Territory Planning
Authority

Pre-decision advice – DA-202443691– Block 10 Section 26 Weetangera

APPENDIX A: ENTITY COMMENTS:

Image 1:

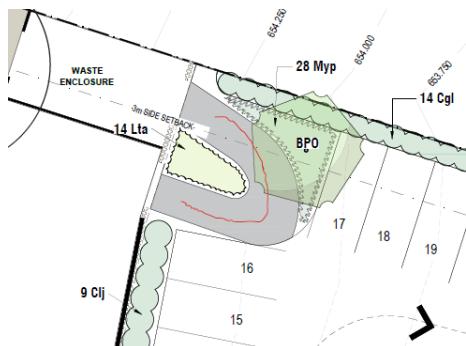
3. Waste collection point/area is non-compliant in accordance with Waste Code requirements which requires hopper pads and therefore, not supported. It is not clear how waste hoppers will be presented for collection in the proposed design as it can be seen in the image 1 below that the space is constrained by parking spaces, no dedicated collection point is provided as required which is a potential safety risks to the carpark users and children in the centre. Please note that Designated collection points must not be located across pedestrian pathway. These comments are in compliance with Clause 7.4 for designated collection point at page 41 of 102 of DCC Code 2019, and A7.5 where it states that "*Loading areas and turning circles for collection vehicles must be designated 'NO PARKING' areas with clear signage*". Find similar advice in EAN24 at page 5 of 14 and across various sections in both documents.

4. It is also not clear from image 1 about the use of the roadway (marked in image 1), whether it will be used by pedestrians or vehicle. And also, Site Plans do not provide understanding/indication on plans for any pedestrian paths or walkways to the centre from the carpark.

Image 2

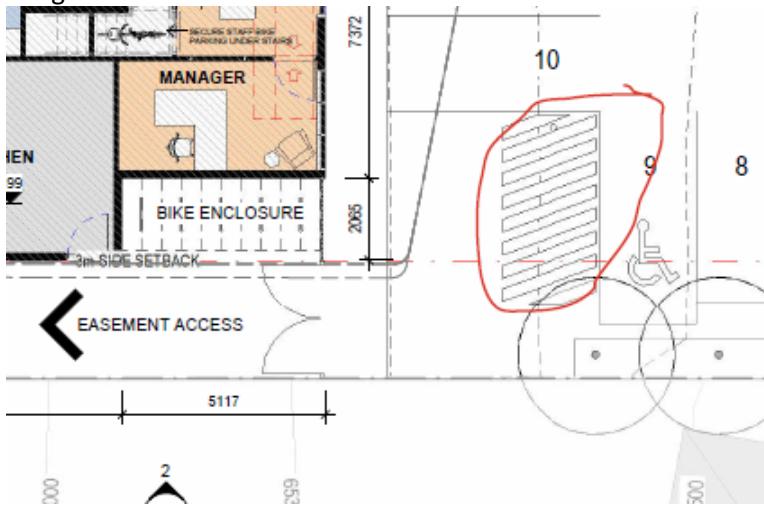
- b. Obstructions and encroachments such as those marked in red circles in Image 2 below is not supported.
 - c. Also note the comments regarding designated collection point in RFI No. 3 and 4 above.

A 2.5m wide and 2.5 m high unobstructed access zone must be provided from the front of the block to the stormwater easement in accordance with BAAN 03. The proposed design does not provide unobstructed access from the roadway/front of the block, refer image 2 below.
